IEEE 802.16m Downlink Resource Mapping

IEEE C802.16m-08/503

Proposal for 16m downlink resource mapping.

Adoption of proposed text/content for 802.16m System Description Document

Proposal for 16m Resource Mapping

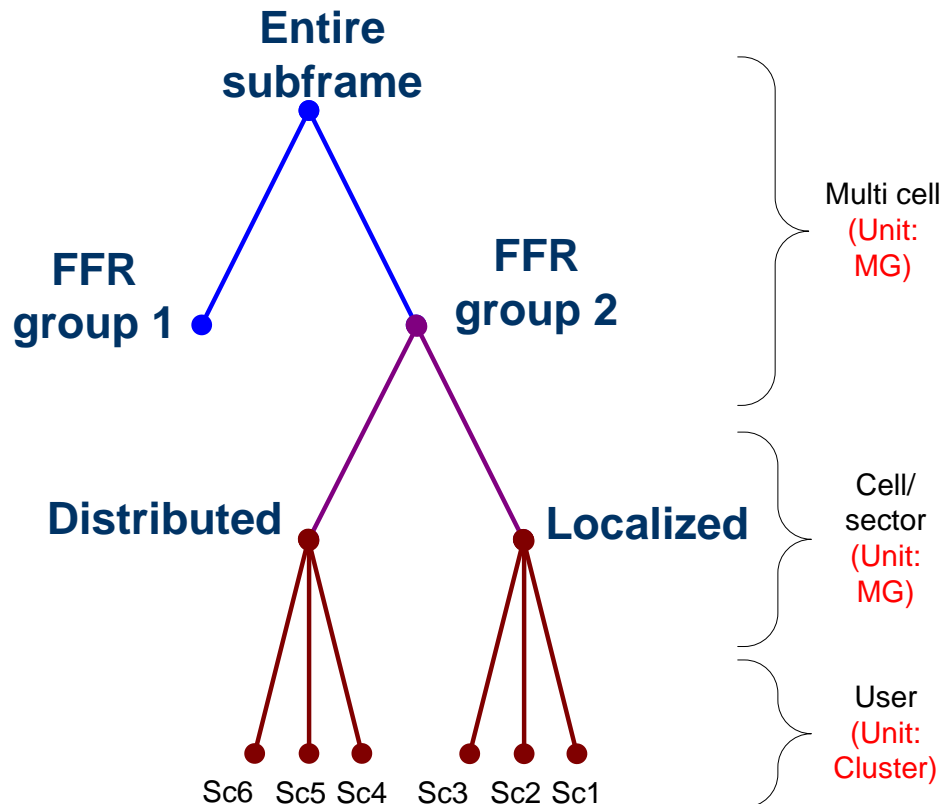
- Replace Fig. 11.5.1 in C802.15mDL_PHY-08/046 by the following figure (including resource unit for each step of allocation in red)
